PROPOSED CARPORT BALCONY
@ 20 ELMFIELD ROAD,
ELGIN, IV30 6HQ.
21/01153/APP

Consultee Comments for Planning Application 21/01153/APP

REPORT OF HANDLING

REFUSAL OF PLANNING PERMISSION

Proposed Side Elevation
(Scale 1:100)

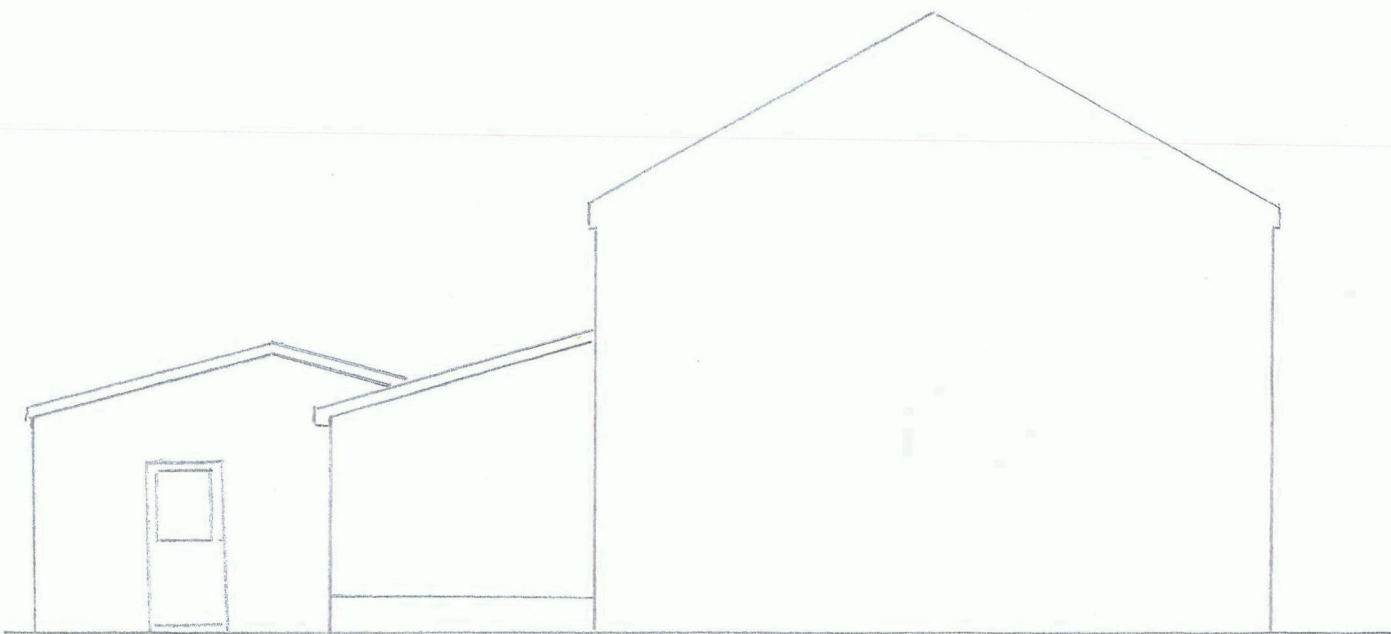
I am today in receipt of the Neighbour Notification re retrospective consent to erect car port with balcony above at 20 Elmfield Road IV30 6HQ. Ref 21/01153/APP. Please note that my only objection to this build is if the front glass panels on the upper balcony are going to be clear glass.

I am concerned that my house will be overlooked and my privacy compromised. All of my front windows look onto this both lower and upper floor and it is in clear view from internally from my living room, bedrooms, bathroom and landing.

I would not object if the glass was to be fully obscured.

A timber staircase to the rear provides access to the balcony area above the car port which is currently enclosed by a timber balustrade on three sides however is proposed to be fitted with a glass panel on the front elevation.

Whilst the carport alone is acceptable and does not give rise to any loss of amenity, the proposed balcony would give rise to an unacceptable loss of privacy and overlooking to the neighbouring property to the south-west of the site.

A timber balustrade has been installed on all three sides of the balcony which is approx. 1.5m high. This is proposed to be fitted with a glass panel on the front elevation but at present this covered by boarding which the applicant advises is temporary. Although a 1.5m screen would help to screen any view into the neighbouring property garden does not fully mitigate any potential loss of privacy or overlooking particularly when in a standing position in the balcony. The applicant has requested that the application be determined as it currently stands and therefore although there may be scope for the balcony to be fitted with higher, fully opaque screening, that is not part of the current application.

The balcony above the carport would also be out of keeping with the scale and character of the existing modest semi-detached dwellinghouse and surrounding streetscape. It is visible from street level and would dominate the side elevation of the existing property in a manner which is overbearing on both the existing main parent property and the character of the surrounding area. It is an unusual feature for this built-up residential area and although there are number of flat roof structures nearby which would allow the carport to integrate easily, the addition of the balcony and balustrade above the carport alters the character of the site and creates a development not typically found in this setting. For these reasons the development would be unacceptable in terms of policy DP1.

1. The balcony would give rise to any unacceptable loss of privacy and overlooking to the neighbouring property to the south-west of the site.
2. The balcony would be out of keeping with the scale and character of the existing dwellinghouse and surrounding area.
